Re: Docket No. 50-275-OL  
Docket No. 50-323-OL  
Diablo Canyon Units 1 & 2

Enclosed are 40 copies of the text for Appendix 45A which is a part of the report D-LL 45 entitled, "Plate Boundary and Diffused Areal Probabilistic Considerations." This report, including the figures for Appendix 45A, was transmitted to you by our letter of December 23, 1977.

SEISMICITY OF THE CALIFORNIA PLATE BOUNDARY SEGMENT  
by Stewart W. Smith

FIGURE 45A-2  
Revised 1-4-'78

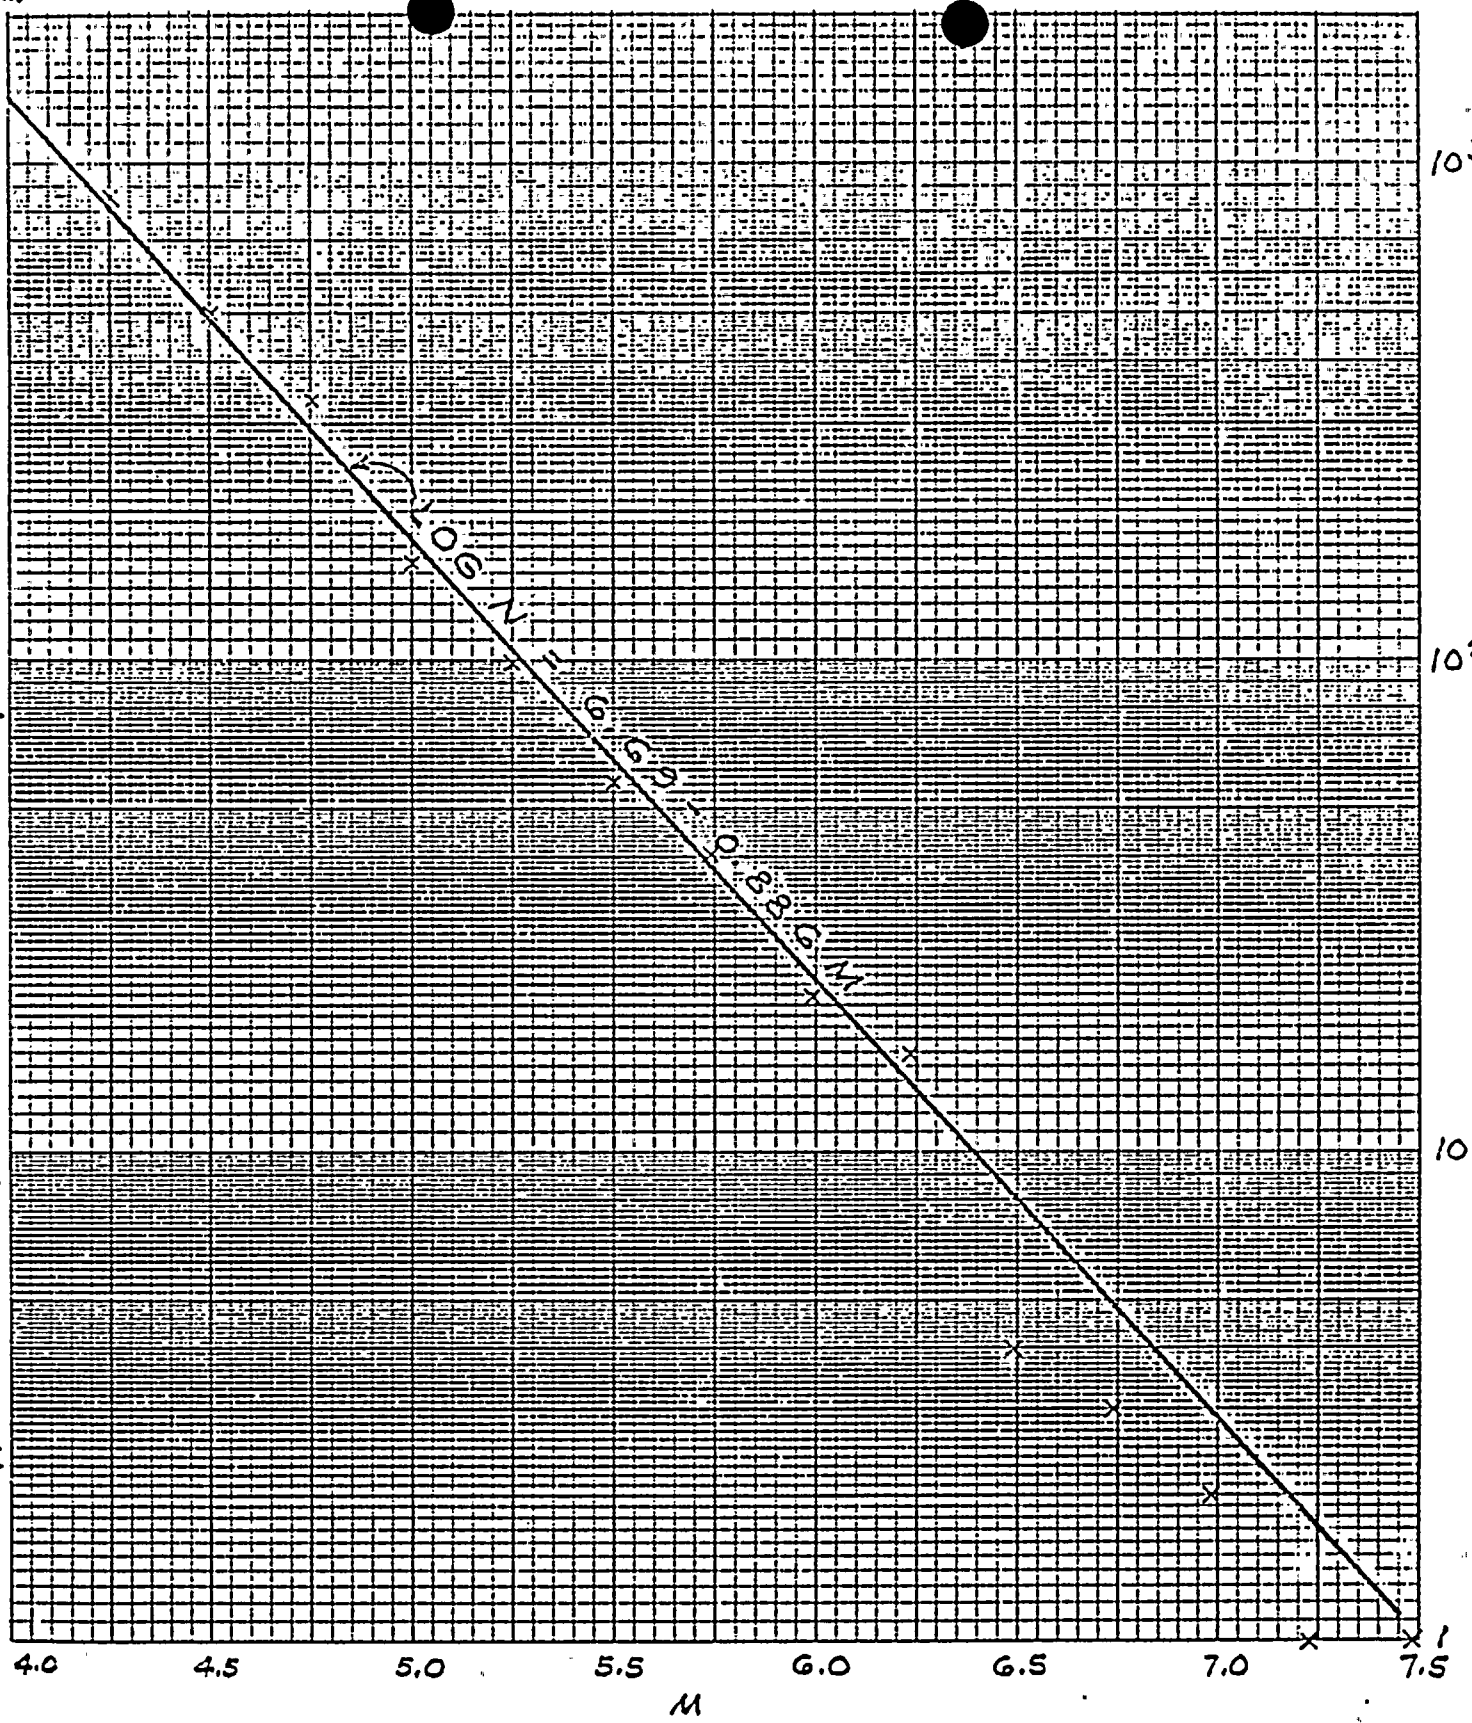
Also enclosed are 40 copies of revised Figure 45A-2 of the Appendix which reflects a slight correction in the 7.5M region.
